Friday 21 April 2023

Columbia High School Baseball and Softball Improvements  
Columbia School District

## ADDENDUM NO. 01

**C201**  
OVERALL SITE  
PLAN

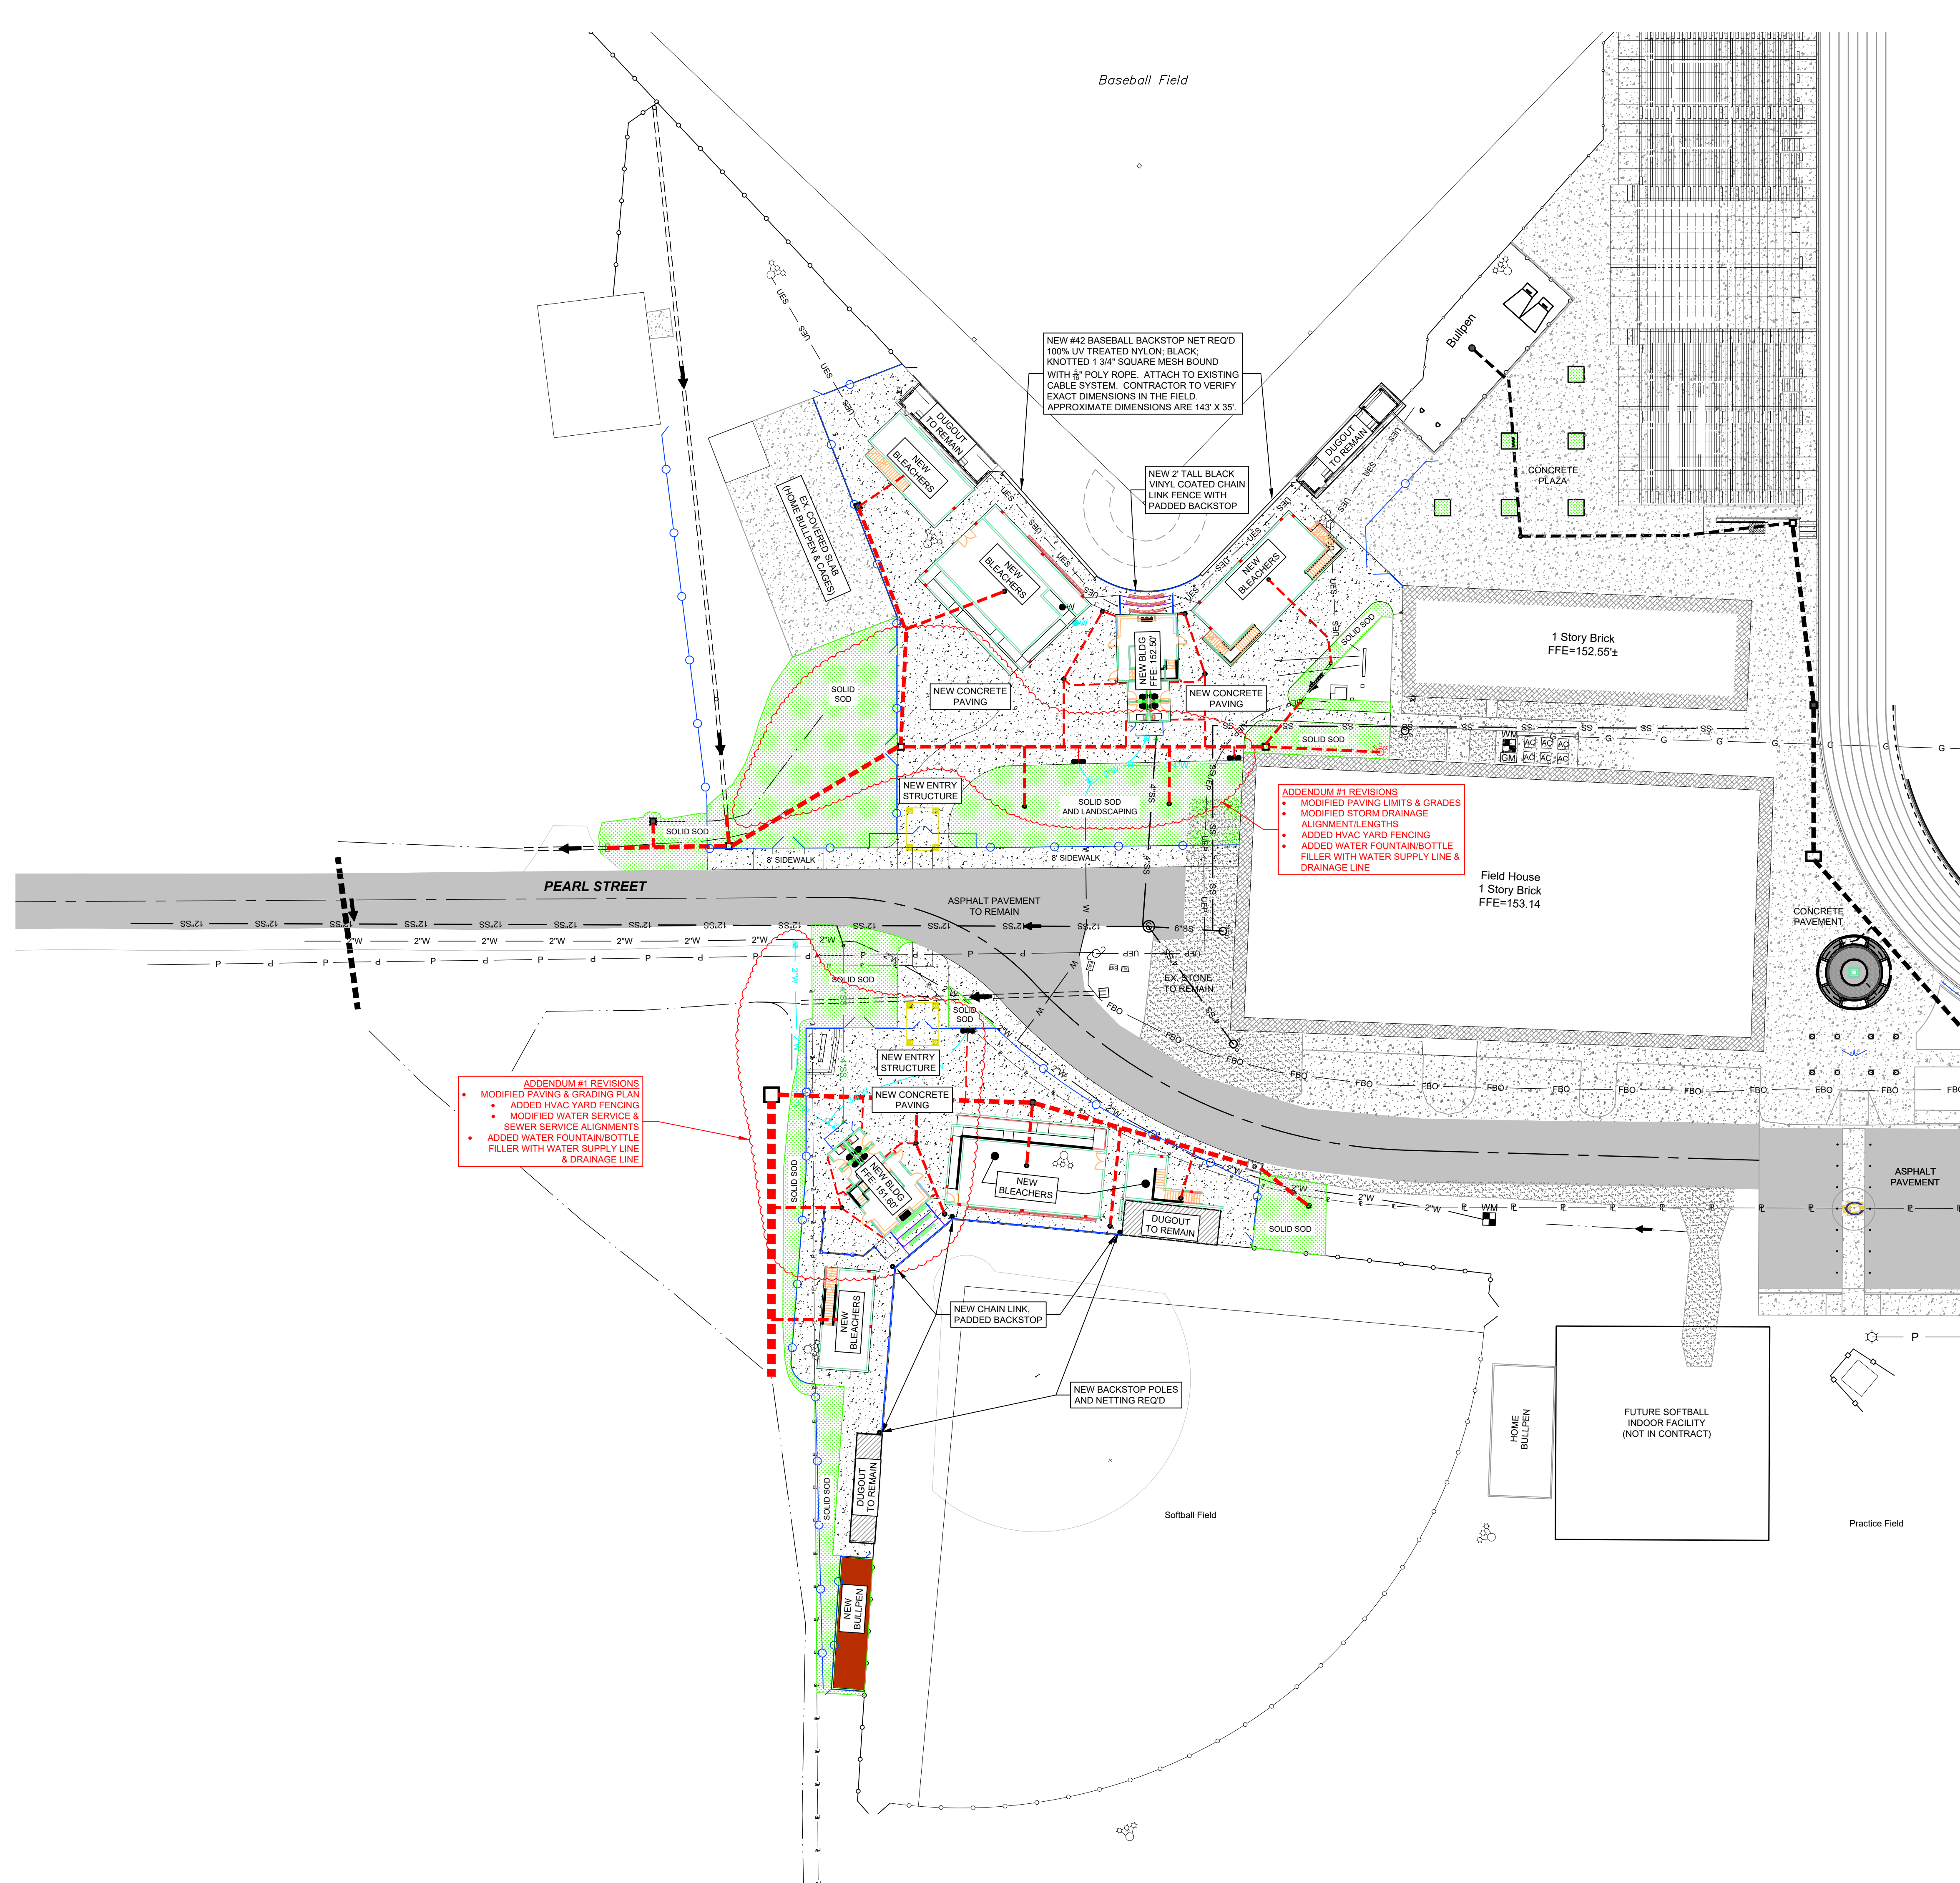
**ADDENDUM #1 REVISIONS**

- MODIFIED PAVING & GRADING PLAN
- ADDED HVAC YARD FENCING
- MODIFIED WATER SERVICE & SEWER SERVICE ALIGNMENTS
- ADDED WATER FOUNTAIN/BOTTLE FILLER WITH WATER SUPPLY LINE & DRAINAGE LINE

**C301**  
DRAINAGE PLAN

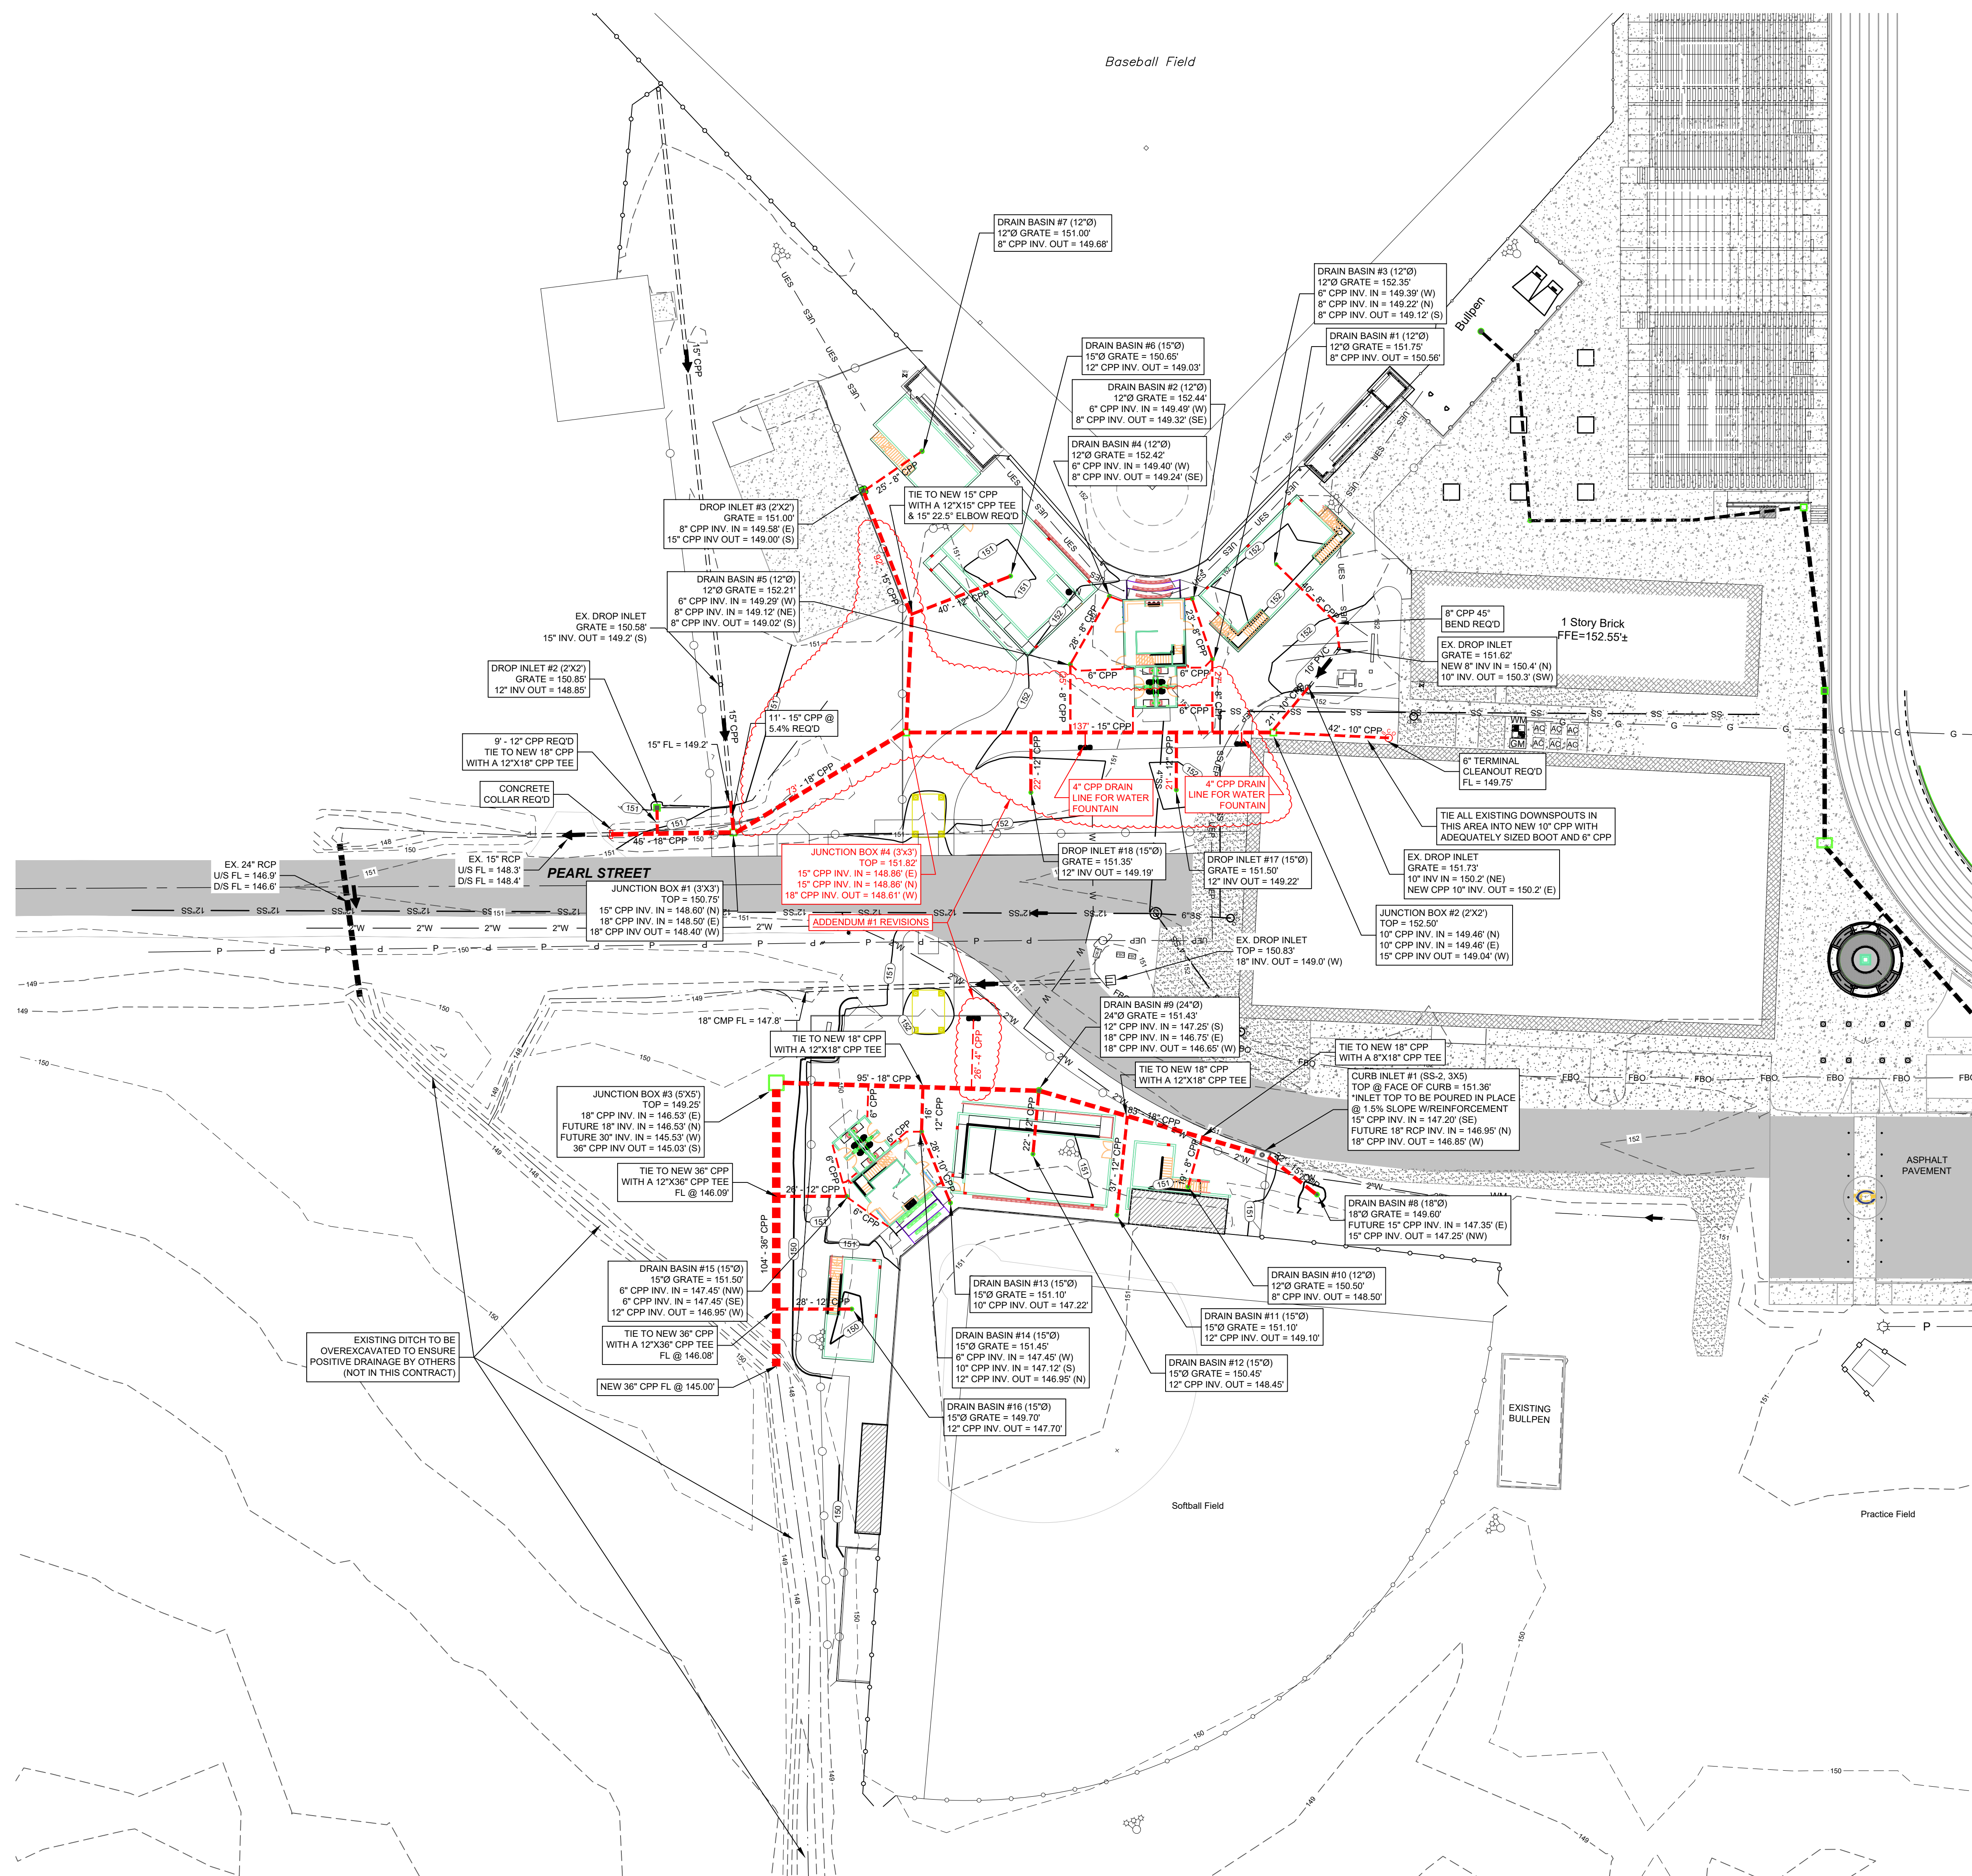
**ADDENDUM #1 REVISIONS**

- MODIFIED PAVING LIMITS & GRADES
- MODIFIED STORM DRAINAGE ALIGNMENT LENGTHS
- ADDED HVAC YARD FENCING
- ADDED WATER FOUNTAIN/BOTTLE FILLER WITH WATER SUPPLY LINE & DRAINAGE LINE
